FTI-TLP4: Vehicle Coverage and Preparation Notes

Overview: Mis-Wired door lock connector, field repair required.

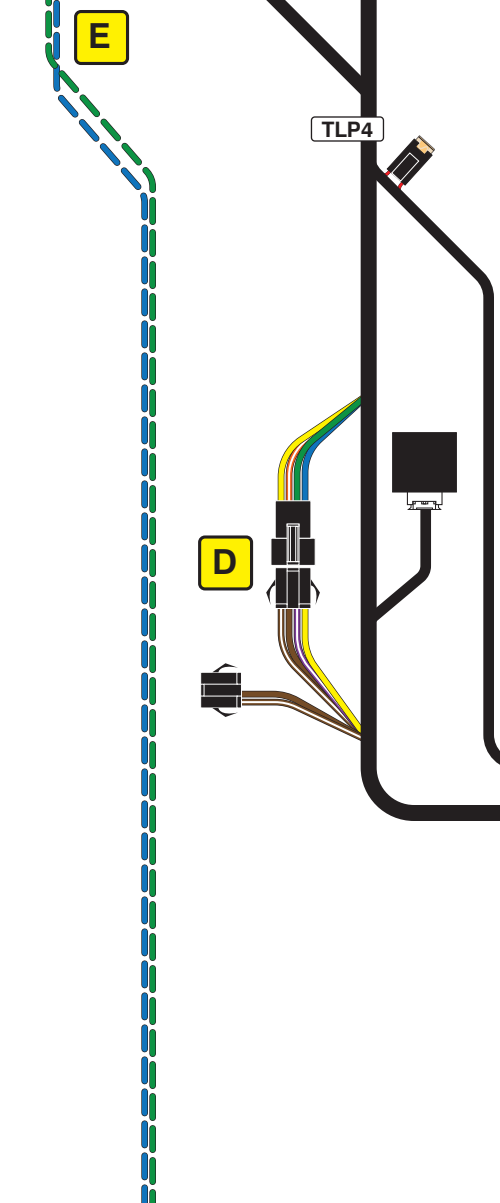
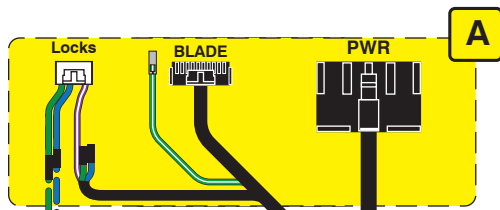
Issue: A review of the latest samples of **FTI-TLP4 T-harnesses** has revealed a misplaced trunk output wire in the 6-pin Lock Accessory Connector requiring that the wire be relocated to the correct position, to ensure safe operation when used. **Using the harness without addressing the issue will result in failed trunk/hatch control, and possible damage to the vehicle BCM.**

Correction: The harness purple/white wire in the latest production run of FTI-TLP4 harnesses has been inserted in the position normally used for the +12V power connection in the accessory harness. Before completing the installation, the installer must relocate the harness purple/white wire to the correct position, 1 space inward on the 6-pin connector, see illustrations below in Fig. 2.

To relocate the terminal, using a fine pick or Olfa type knife, depress the terminal locking barb and pull the purple/white wire from the connector housing. Once the terminal has been removed from the housing, again using the pick or knife, lift the locking barb about 1/16" (1.5 mm) and reinsert the terminal in the correct position. If upon initial examination of the harness the lock accessory connector looks like the illustration in Fig. 2, no modification is necessary, the wire is in the proper position.

E Door Lock Connections

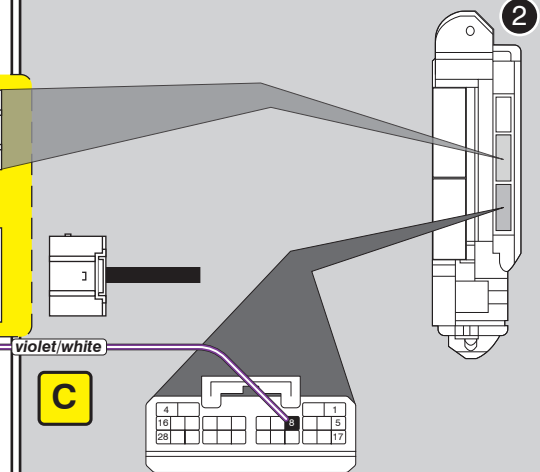
Locks: This install requires additional connections to the driver door module (DDM) ensuring proper synchronization with the OEM remotes. **The 6-pin connector must be modified as illustrated, and wires extended to the DDM for correct operation.**
